UNITED STATES PATENT AND TRADEMARK OFFICE

APPLICATION NO.	FILING DATE	FIRST NAMED INVENTOR	ATTORNEY DOCKET NO.	CONFIRMATION NO.
10/608,671	06/27/2003	Michael J. Pugia	017191.0033 (MSA-3452)	5201

Office Action Summary

DETAILED ACTION***Drawings***

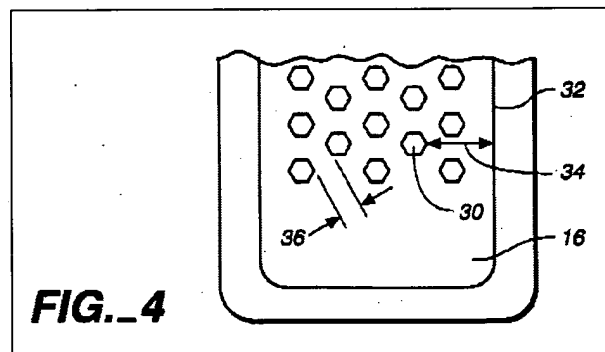
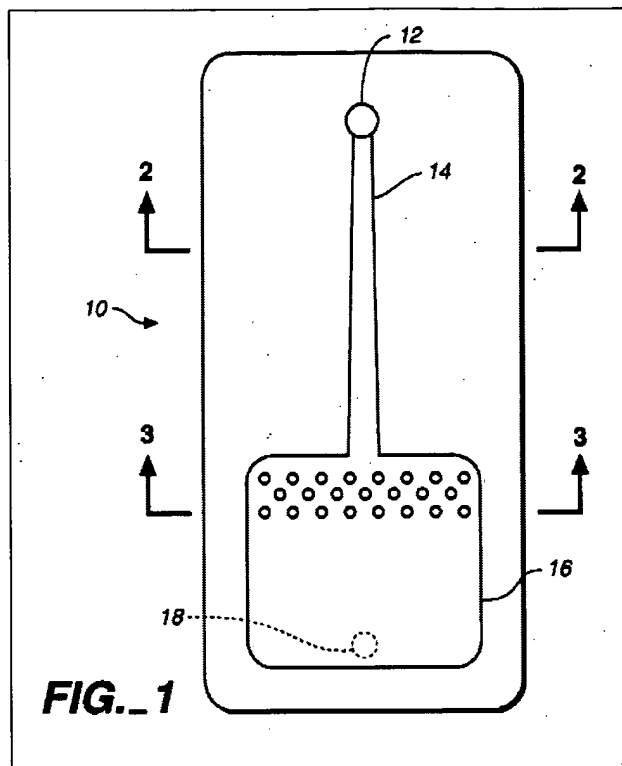
Regarding claim 1, Buechler anticipates a microfluidic device comprising: an inlet port 12; an enclosed capillary passageway 14 in fluid communication with the inlet port 12; an enclosed inlet chamber (e.g., distal region 16) comprising an array of post structures (i.e., capillarity-inducing structures 30); and a vent structure (i.e., escape port 18) (see col. 5, line 21 – col. 7, line 43; figures 1 & 4). As shown in figure 1, the enclosed inlet chamber 16 is in fluid communication at one side or end side thereof with the enclosed capillary passageway 14. In addition, as shown in figure 1, the vent passageway 18 is positioned at a top side of the enclosed inlet chamber opposite the entry of the capillary passageway 14 into the enclosed inlet chamber 16.

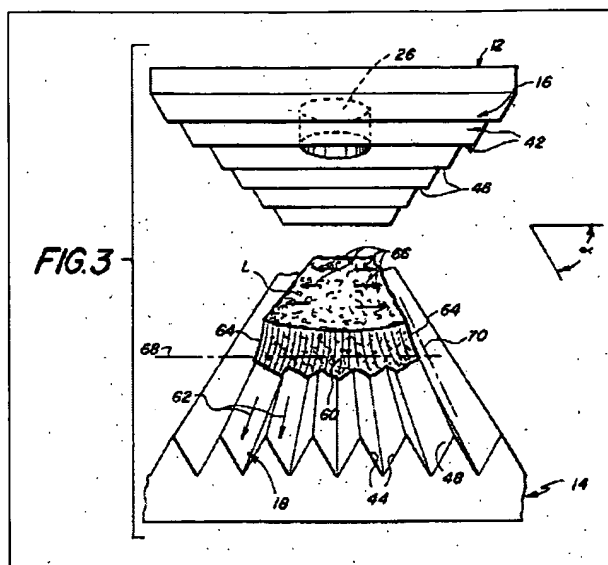
Columbus teaches the use of groove structures (e.g., 42 & 44) for facilitating uniform fluid flow within microfluidic devices (see, e.g., col. 5, lines 1 – 55; figure 3).

Hence, as shown by Columbus, a person of ordinary skill in the art would accordingly have had a reasonable expectation for success in incorporating the use of a groove structure with an analytical microfluidic device for facilitating uniform sample fluid introduction into the device for processing and analysis (see MPEP § 2143.02). Therefore, it would have been obvious to a person of ordinary skill in the art to incorporate a groove structure as claimed with the disclosed microfluidic device.

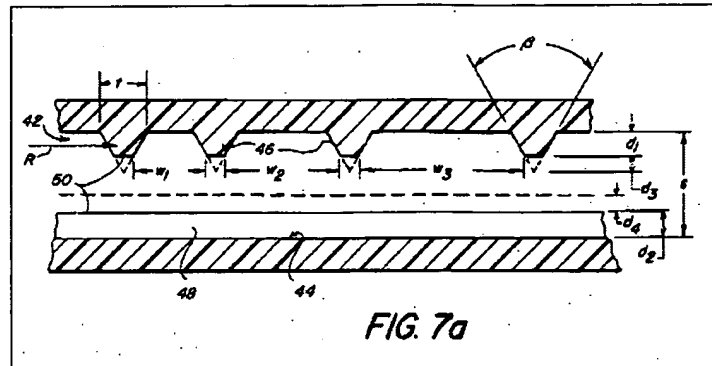
Regarding claim 3, as shown in figure 7a, Columbus further teaches the incorporation of weir structures (e.g., truncated ridges 46) within the device (see, e.g., col. 8, lines 1 – 51). Therefore, it would have been obvious to a person of ordinary skill in the art to incorporate a weir structure as claimed for facilitating effective sample fluid flow with the disclosed microfluidic device.

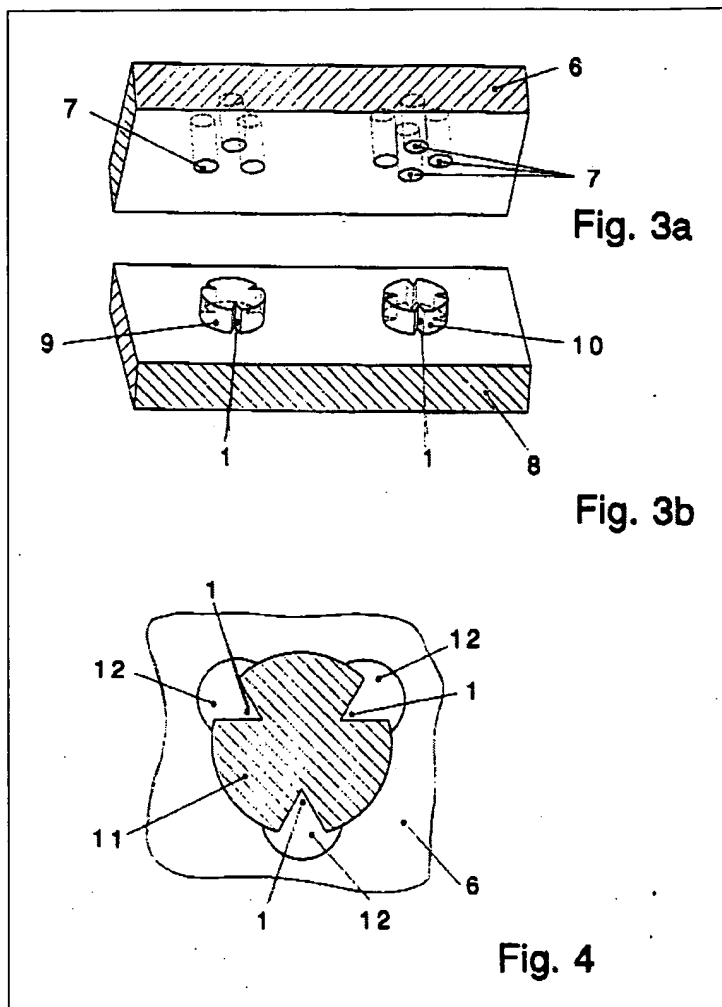
Regarding claims 4 and 6, Buechler and Columbus are silent to the specific teaching of incorporating wedge-shaped cut-out structures with either a groove or weir structure within the disclosed microfluidic device. As shown in figure 3b, Peters does teach the incorporation of wedge-shaped cut-out structures (post or columnar projection 9 having wedge-shaped cut-outs 1) within a microfluidic apparatus for facilitating effective fluid control within a microfluidic device (see col. 1, line 10 – col. 6, line 67; figures 1a, 3b & 4).

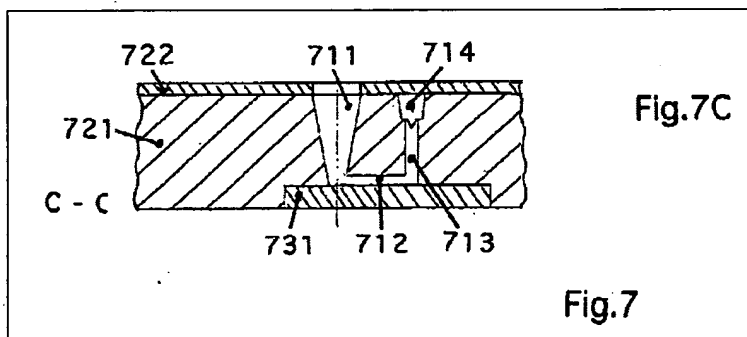
Wyzgol teaches a similar analytical microfluidic device comprising a tapered, funnel-shaped inlet port 711 designed for taking up the tip of a pipette for facilitating sample introduction into the device (see, e.g., col. 8, lines 30 – 37; figure 7 (7C)).

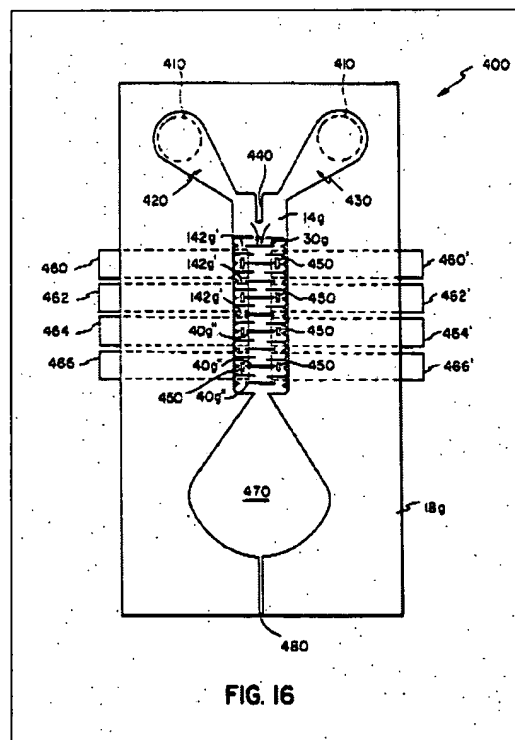
Columbus '476 teaches the incorporation of an overflow chamber 470 within a microfluidic device to facilitate effective sample fluid introduction and subsequent processing (see figure 16). Therefore, it would have been obvious to a person of ordinary skill in the art to incorporate an overflow chamber within the disclosed microfluidic device to facilitate effective sample fluid introduction and subsequent processing.
